July 16, 2014

Re: **Arizona Department of Environmental Quality 401 Certification for Rosemont
Copper, Public Notice 27-14AZ LTF 55425**

Impacts of the Rosemont Mine on Hydrology and Threatened and Endangered Species of the Cienega Creek Natural Preserve

Figure 6. Tetra Tech’s (2010a) Figure 5, amended to show actual channel bed elevation at the location. Red line shows position of the 2008 and 2011 channel bed based on LiDAR data.

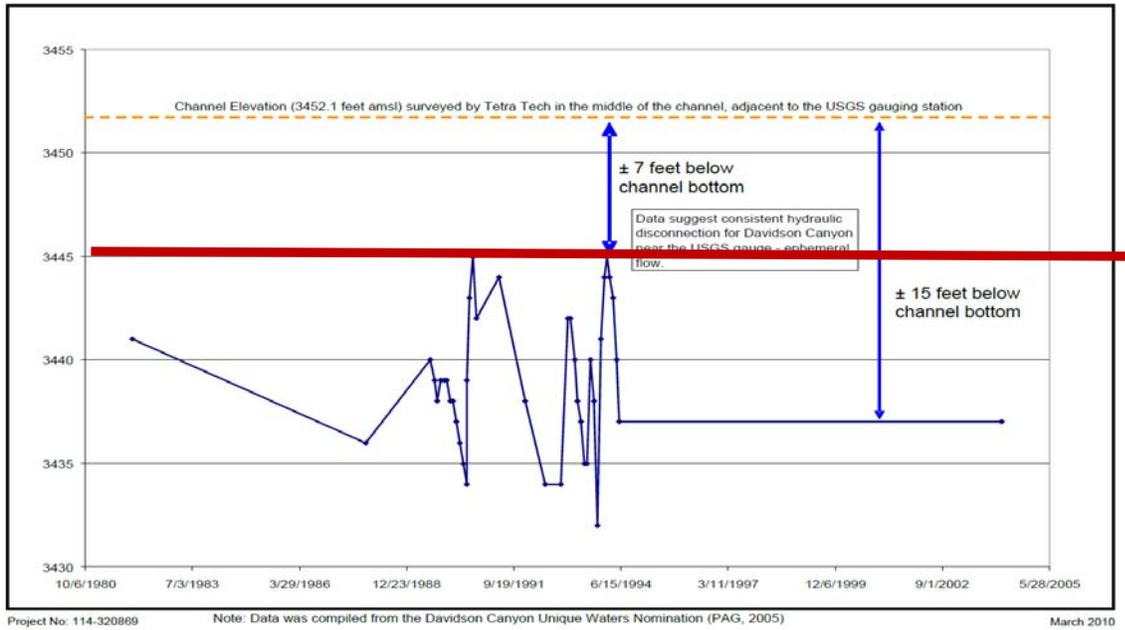
We also take issue with Tetra Tech (2010a) data. Underpinning Tetra Tech's assertion is an illustration and a channel bed measurement at the Davidson Canyon stream gage (Figure 6). The accuracy of this figure relies on a "mid-channel bed" measurement taken by Tetra Tech (2010a). We examined Pima County LiDAR-generated elevation data at the same location and found that Tetra Tech's "mid-channel" bed elevation is five feet higher than the channel bed in 2008. We then examined 2011 LiDAR bed-elevations at the same location, which rule out the possibility that five feet of aggradation occurred, as would be required by Tetra Tech channel bed measurement. Instead, the actual bed elevations in 2008 and 2011 vary by less than 0.6 feet (Figure 7). Thus, the actual channel-bed is within a foot or two of the water table as measured in Davidson #2 Well.

The water-level measurements presented by Tetra Tech came from the Outstanding Waters nomination submitted by Pima Association of Governments (2005), which identified this reach as intermittent. Tetra Tech (2010a) uses the same data to infer that this portion of the channel is ephemeral. It is unreasonable to assume that groundwater never could discharge to the surface, or that it has been persistently below the bed between 1994 and 2004, as is indicated by Tetra Tech with the horizontal line connecting the last two groundwater measurements (Figure 6). It is even more unreasonable to extend that inference to the entire upstream reach, as is done by Tetra Tech (2010a).
